Safety Alert # 4058

Mark III Modular Drilling Control Pod SEM (Subsea Electronics Module) Indication Faults

Indication Fault #1

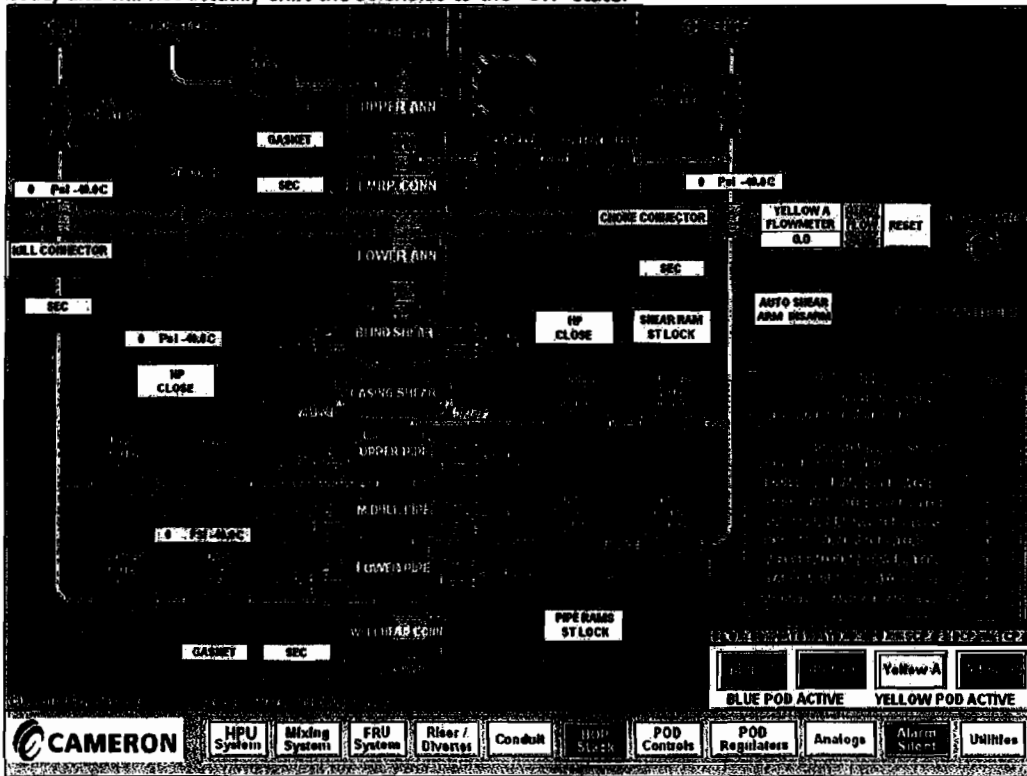
The active SEM indicates going to a "both Diagnostic points on" condition. The HMI BOP screen will show the valve position tag on the screen turning "black" which indicates that the active SEM is reporting back that all solenoids are in the "ON" state (see below screen capture). We have not experienced more than one SEM (Blue A, Blue B, Yellow A, Yellow B) going to this state. This solenoid "ON" position state is an indication issue, and will not actually shift the solenoids to the "ON" state.

The above "Indication Faults" have been traced to the Application Software that is installed on the I/O board within each SEM (there are 2 sets of electronics within each SEM Housing, A and B per Pod). A revised version of the I/O Board Application Software will be required to be downloaded onto each I/O Board and compiled for proper operation. The corrective action can only be accomplished by removing the SEM Cover and gaining access to the individual I/O boards while the system is on the surface. These activities can only be undertaken by authorized Cameron Service Personnel.

Indication Fault #2

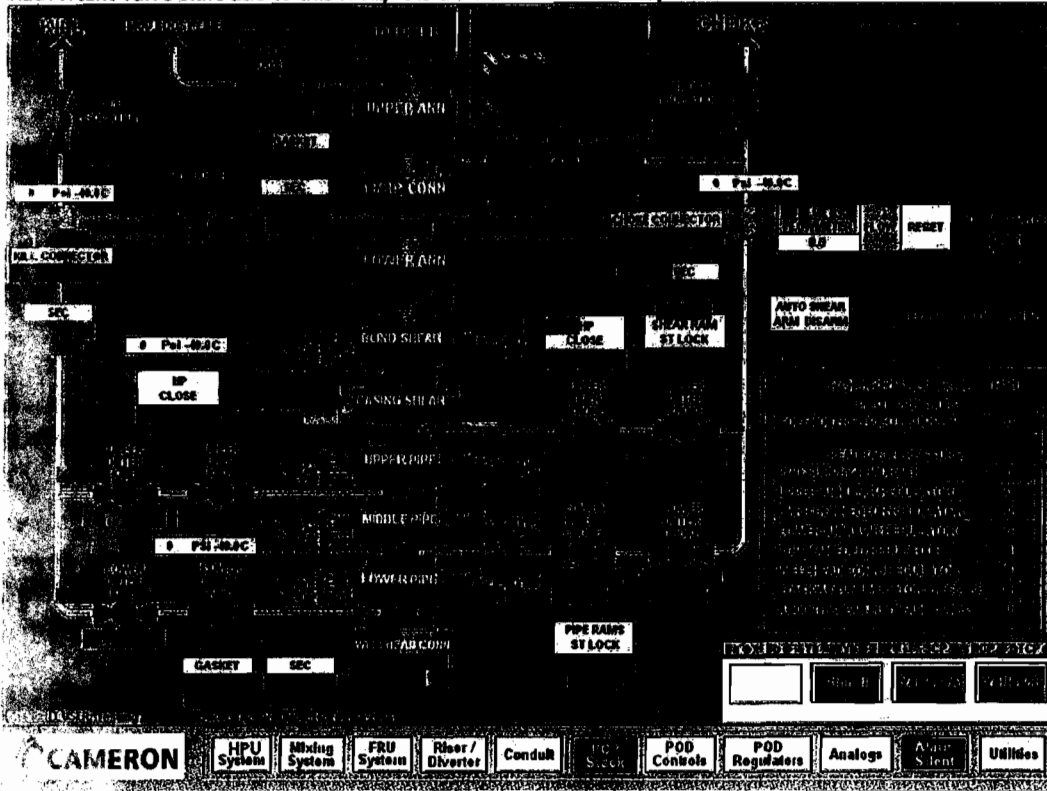
Additionally, we have experienced a single SEM going to a "NO" DSDM (Drilling Solenoid Driver Module) state, which is indicated with the HMI valve position Tag names going to a "Black state" with the word "LOCKED" in the place of the valve position (see below screen capture). This is indicating that the "active" SEM is not recognizing the DSDM (Drilling Solenoid Driver Modules). At no time have we experienced an inadvertent valve shift due to this fault, it is an indication issue only.
